TOWN OF AURORA

Another situation has arisen which clearly circumvents the Boards attempt to maintain the rural character of the Town through the establishment of the ODA Code.

718 Jewett Holmwood Roa East Aurora, NY 14052

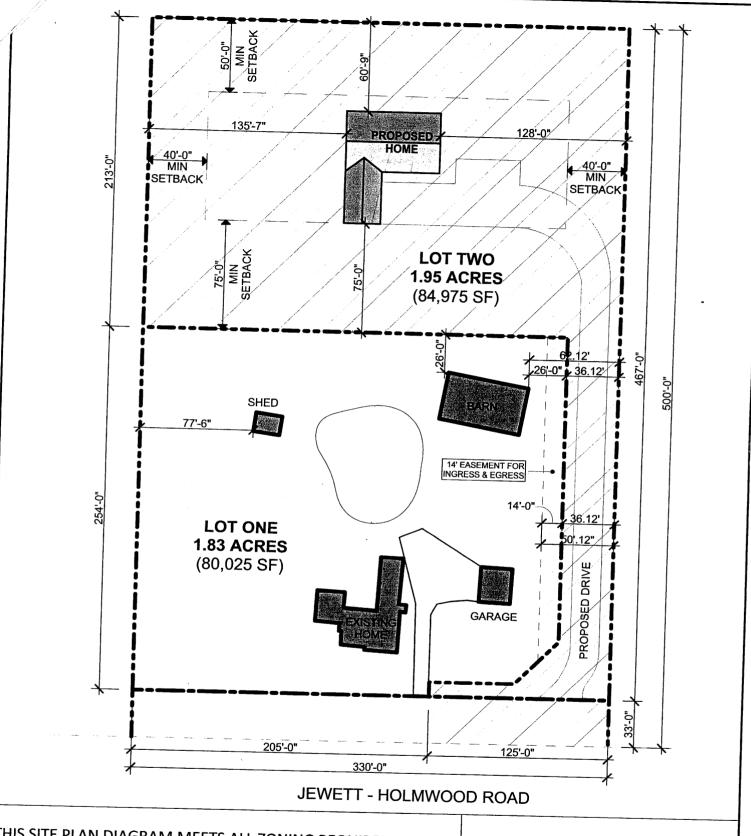
The survey provided illustrates the creative use of the inadequacies of the ODA code to create buildable backlots without going through the ODA process. The prospective purchaser of this property has carved out the 125' of frontage to create a buildable lot without going through the ODA process. The 125 ft. is in an RR District and through the exception to the A District minimum lot size found in section 116-25 the RR lot size and setbacks are allowable for the rear lot which is mostly in an A District.

Without the 125 ft. frontage this lot would have had to go through the ODA process. It would have had to have been three acres in area exclusive of the flag pole area, any home would need 200 ft. front yard setback, 50 ft. rear yard setback and would be unbuildable without a few variances.

I have not done any research on how often this could happen in the town, nor do I have an immediate suggested code change to solve the problem, but this is a clear attempt to get around the spirit and intent of the Town Code. If the Town Board is in agreement I would suggest reviewing the current code and making changes to close this loop-hole without creating any other adverse situations.
